Re: Boat Lifts at the Ocean Springs Harbor

SECTION 00901-02
ADDENDUM NO. 2

Project: Boat Lifts at the Ocean Springs Harbor	Owner: Mississippi Department of Marine Resources	Engineer's Project No.: 216-015
--	--	------------------------------------

S3.1
SHEET OF

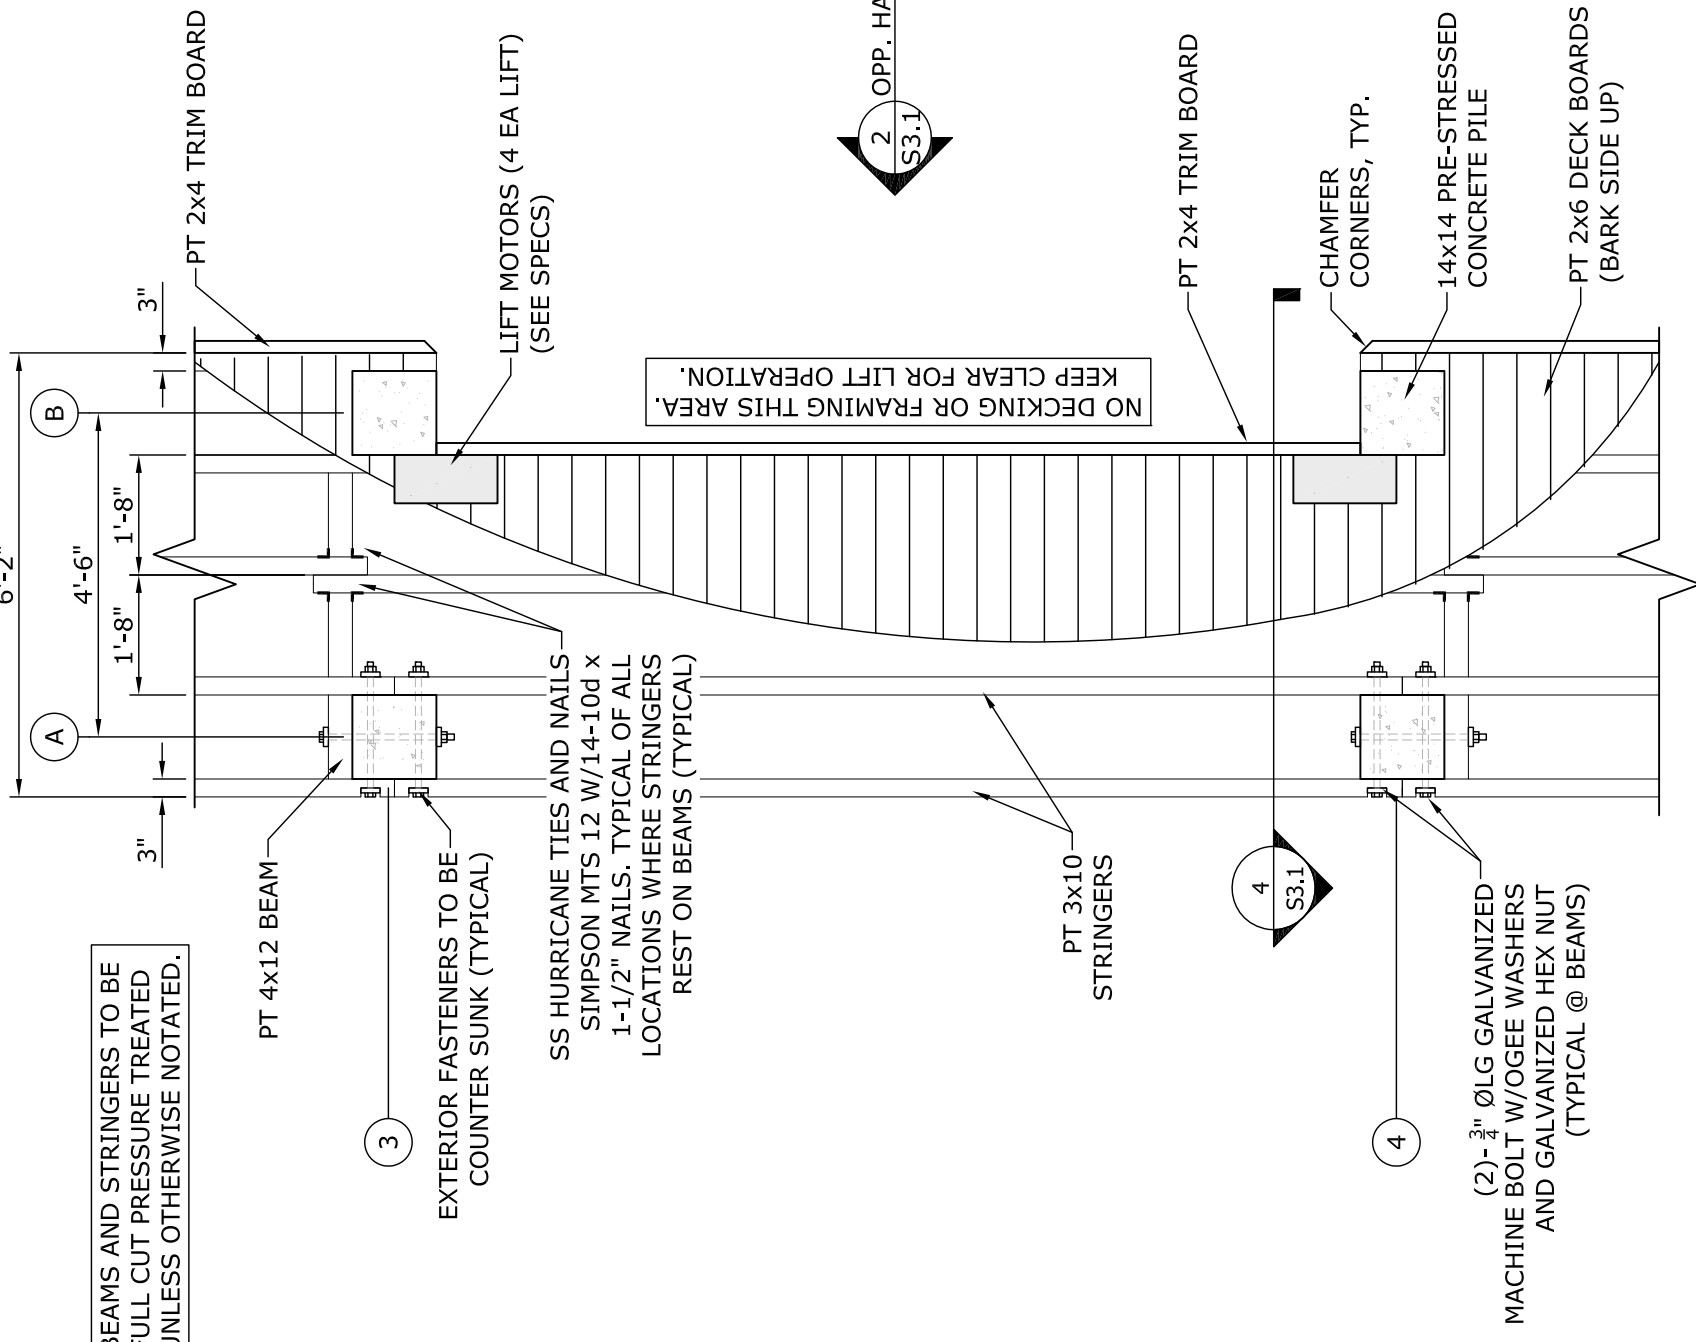
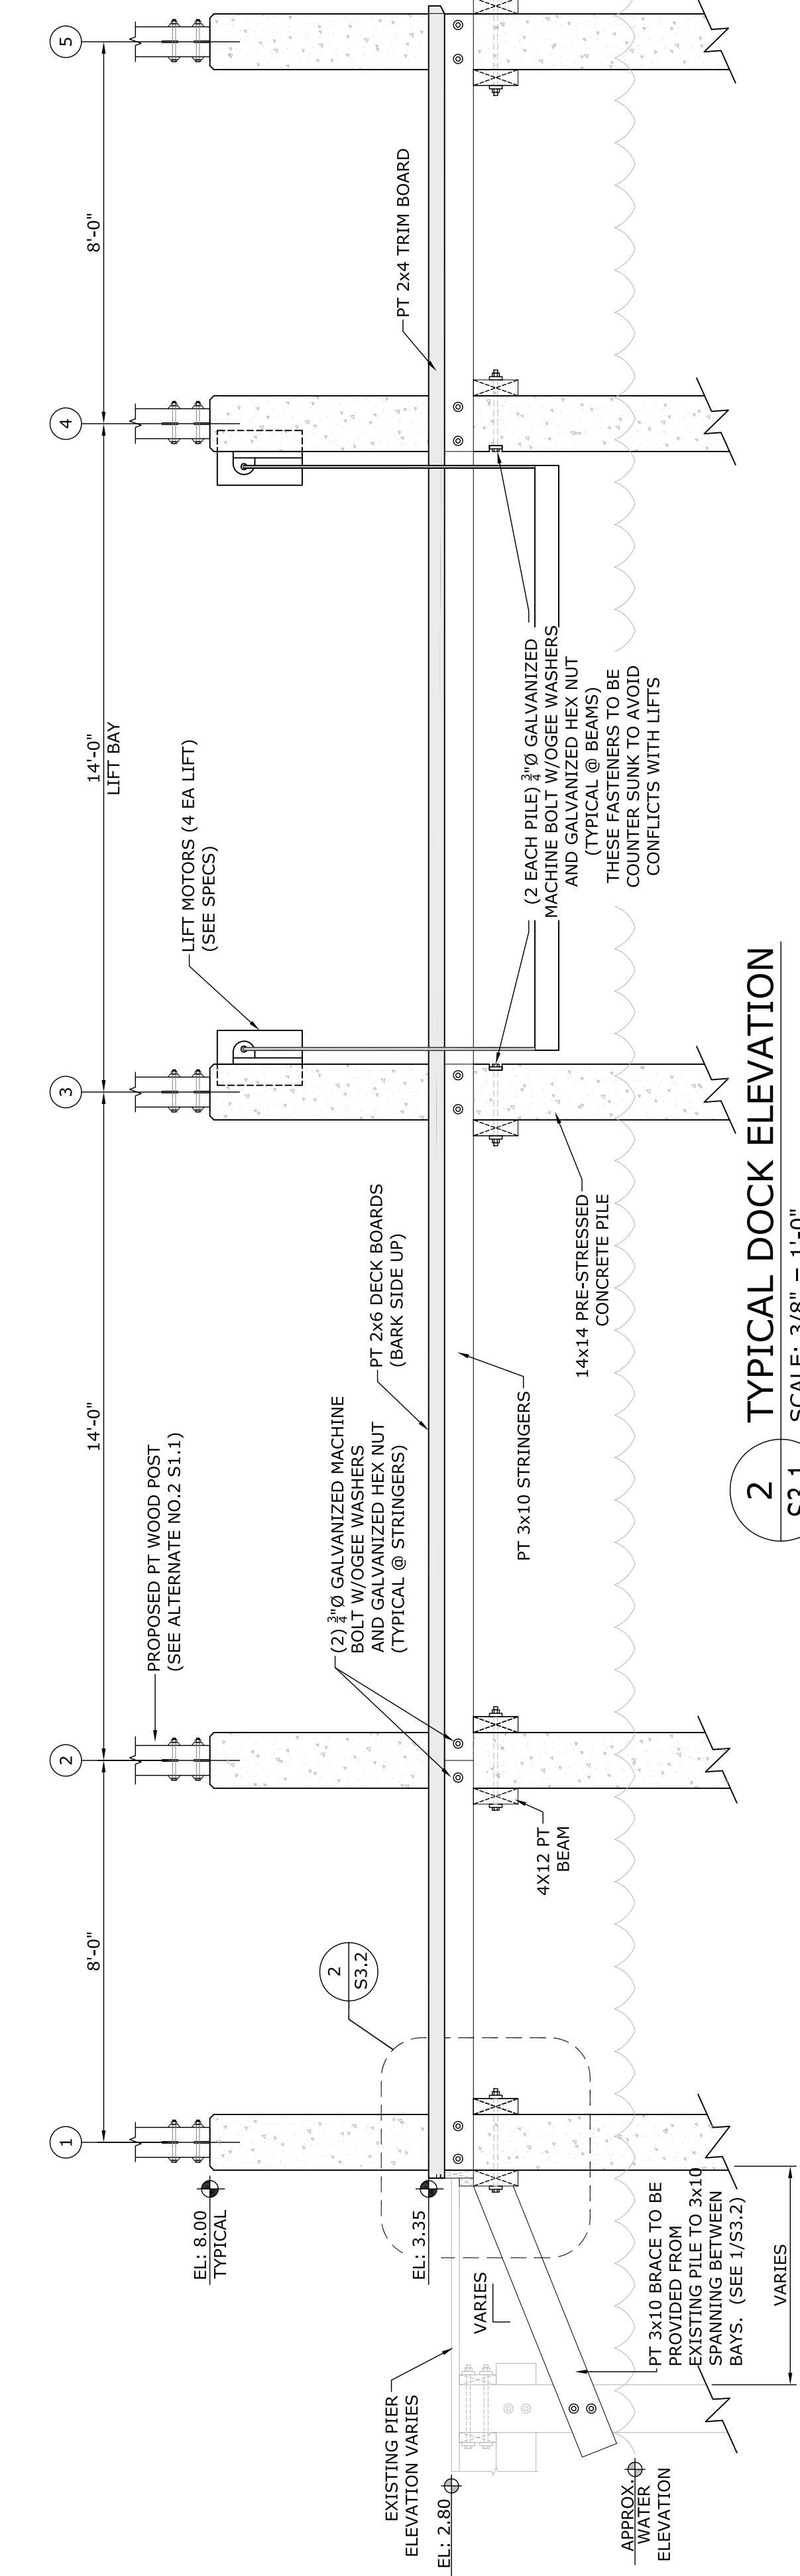
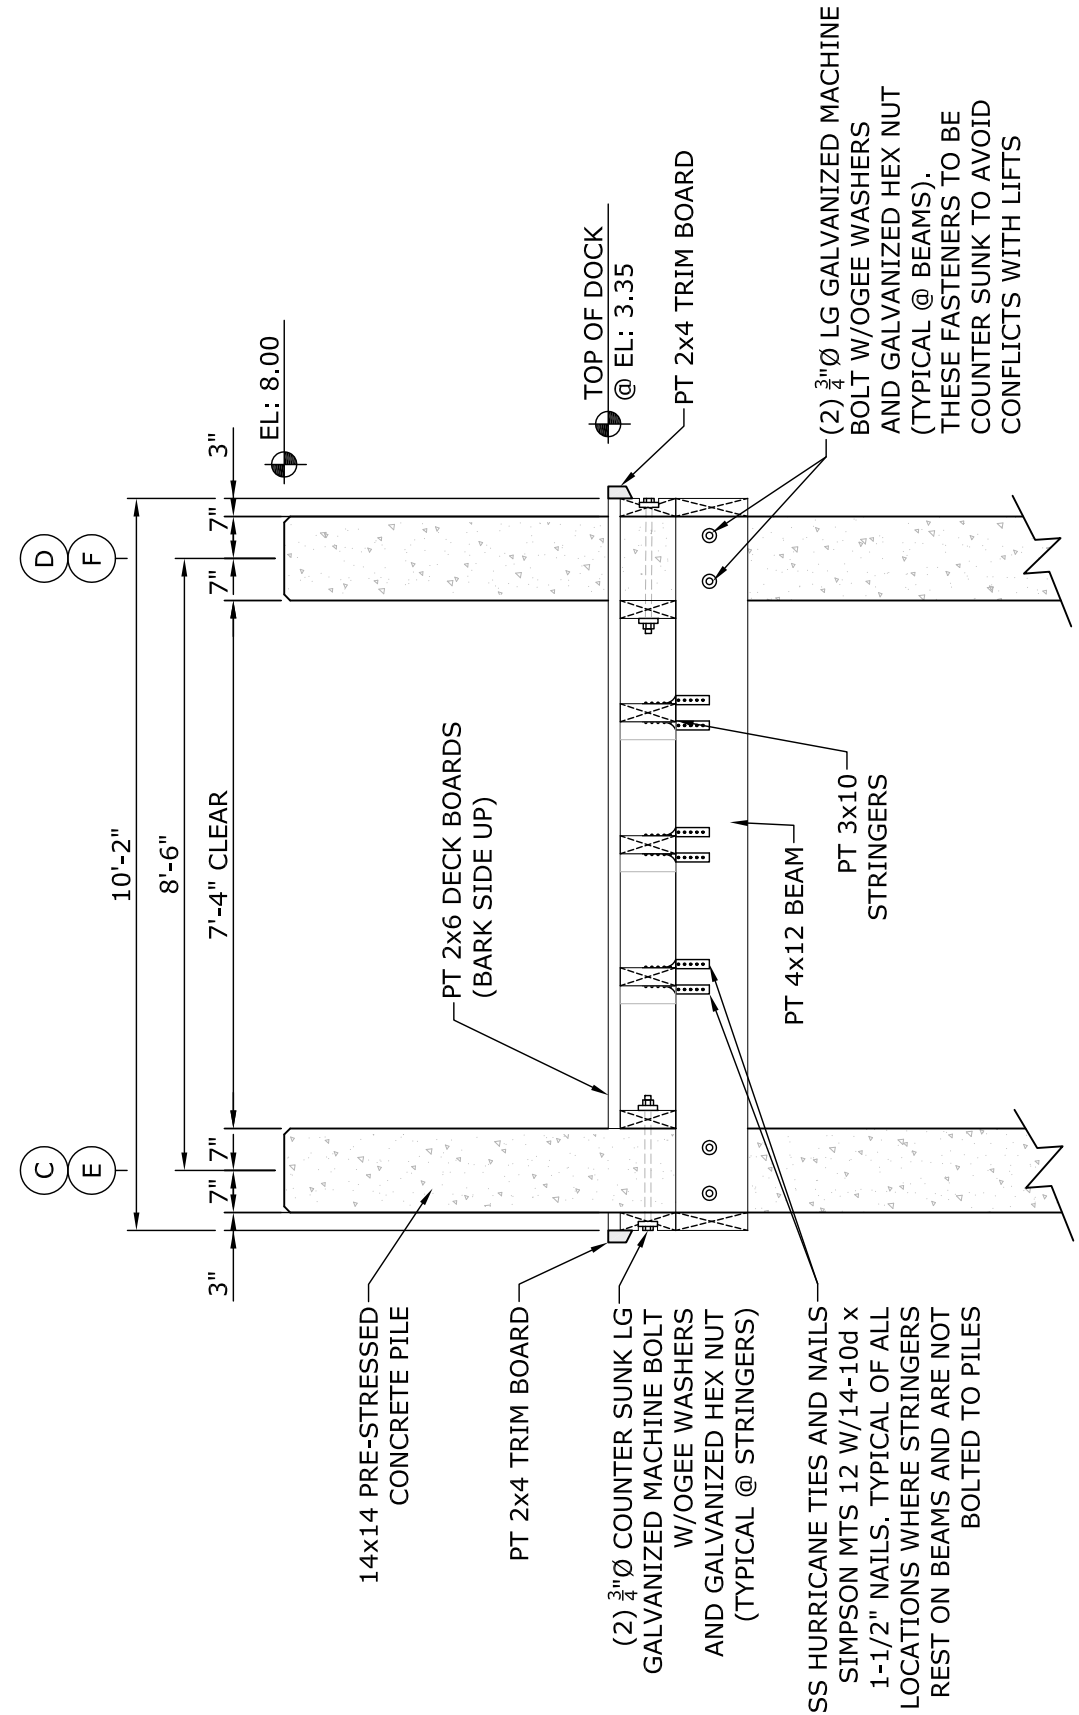
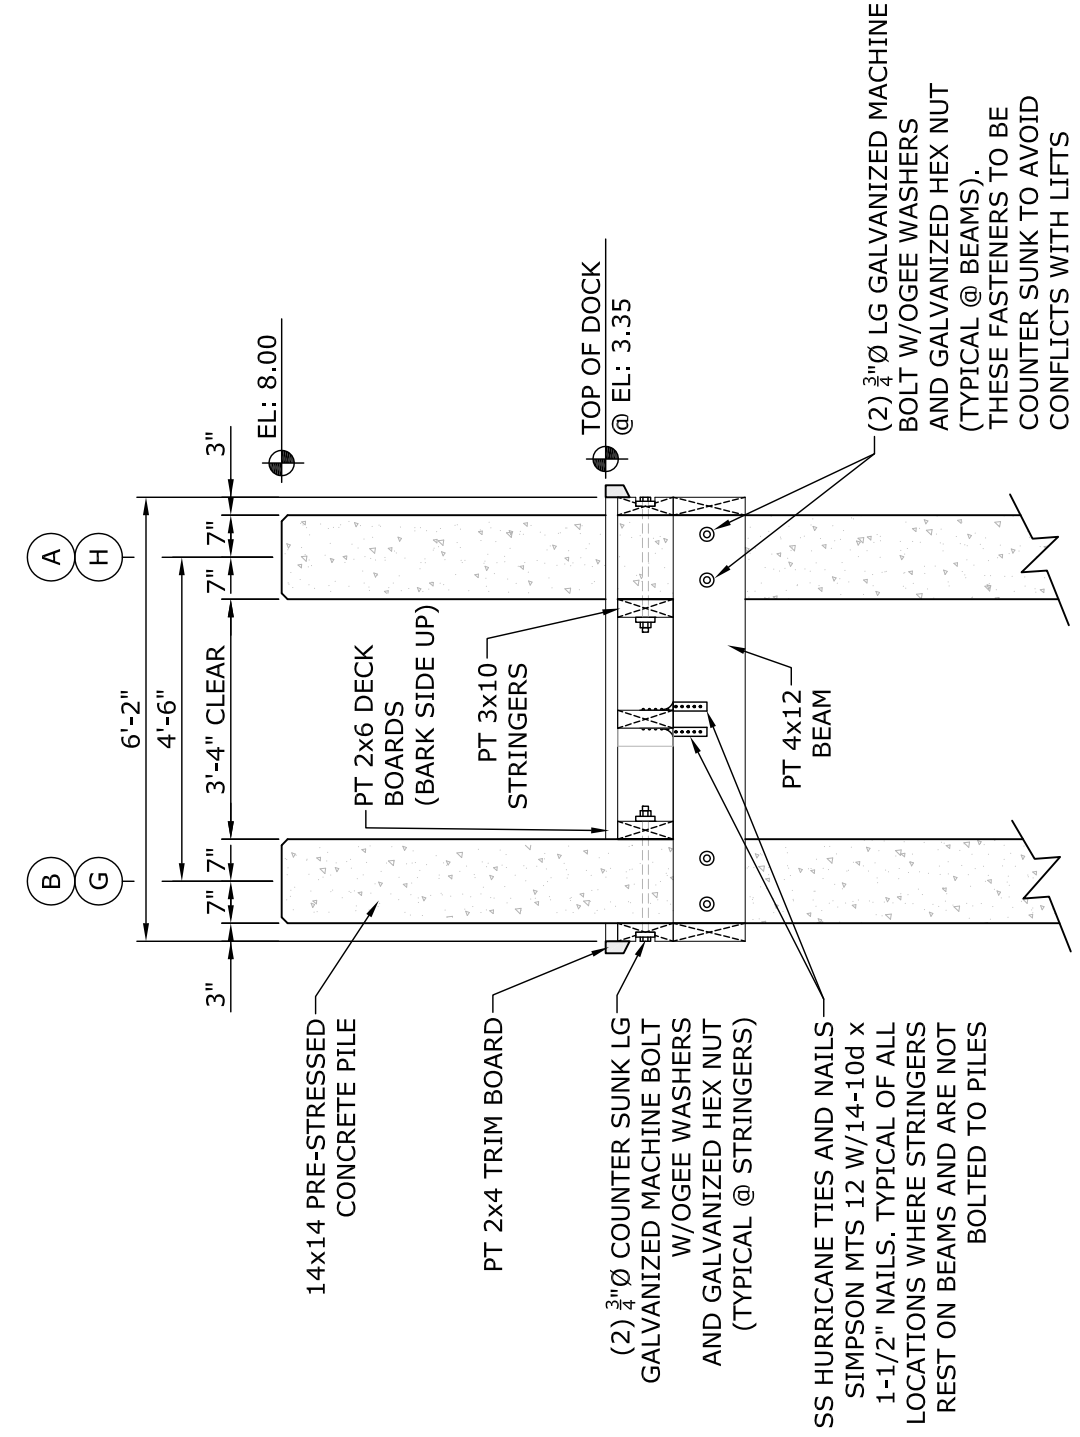
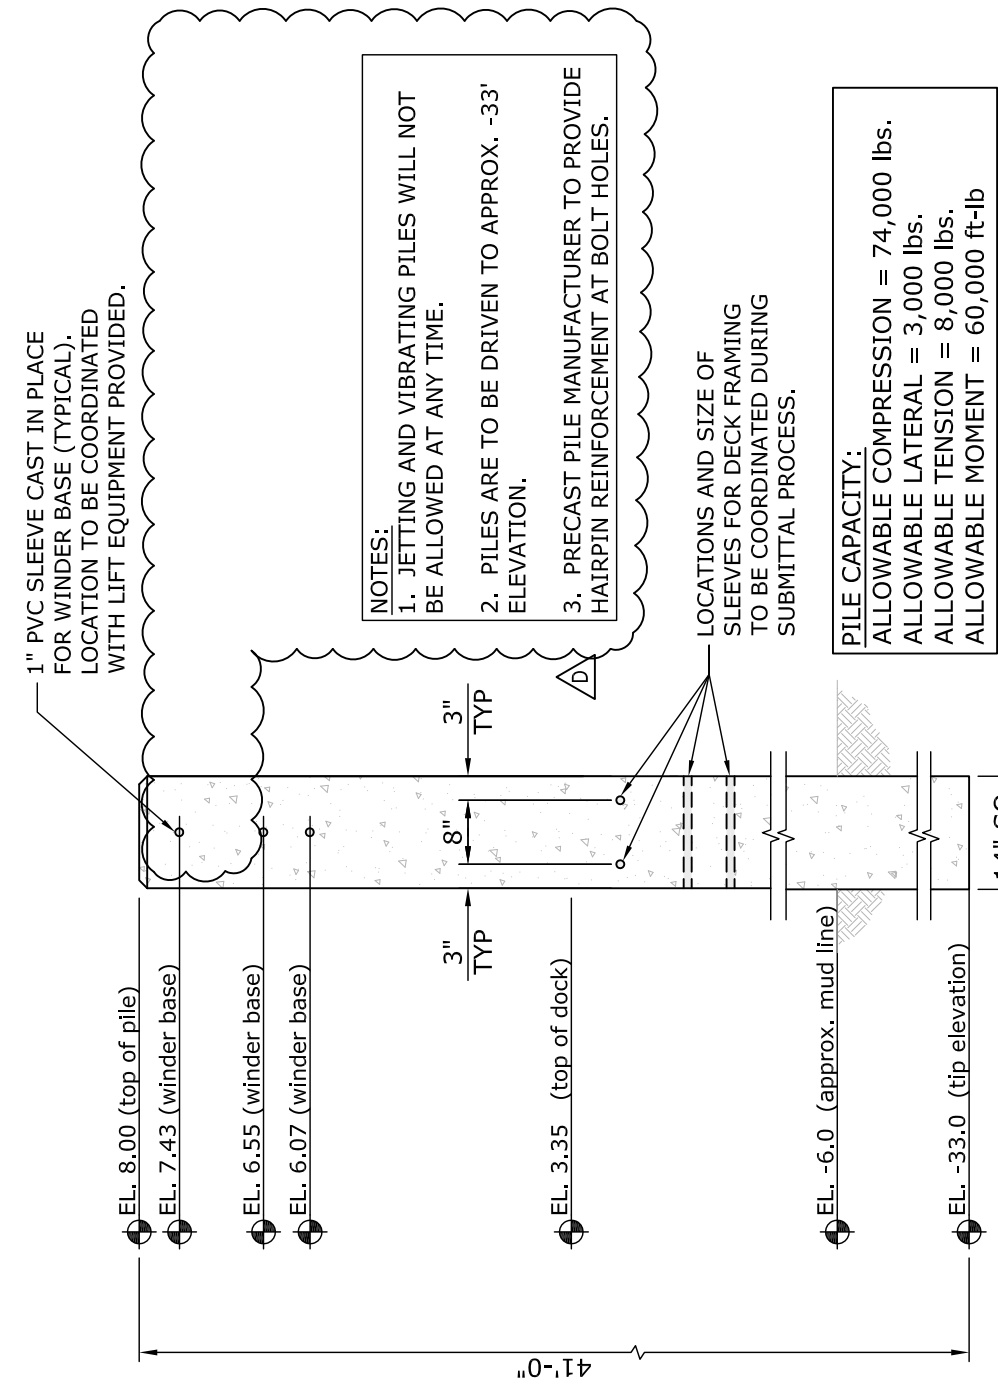
2. SHEET S3.1

Delete Sheet S3.1 in the project manual and replace with **Attachment #2 to Addendum #2.**

Notable Changes:

- a. Pile load tests will not be performed.
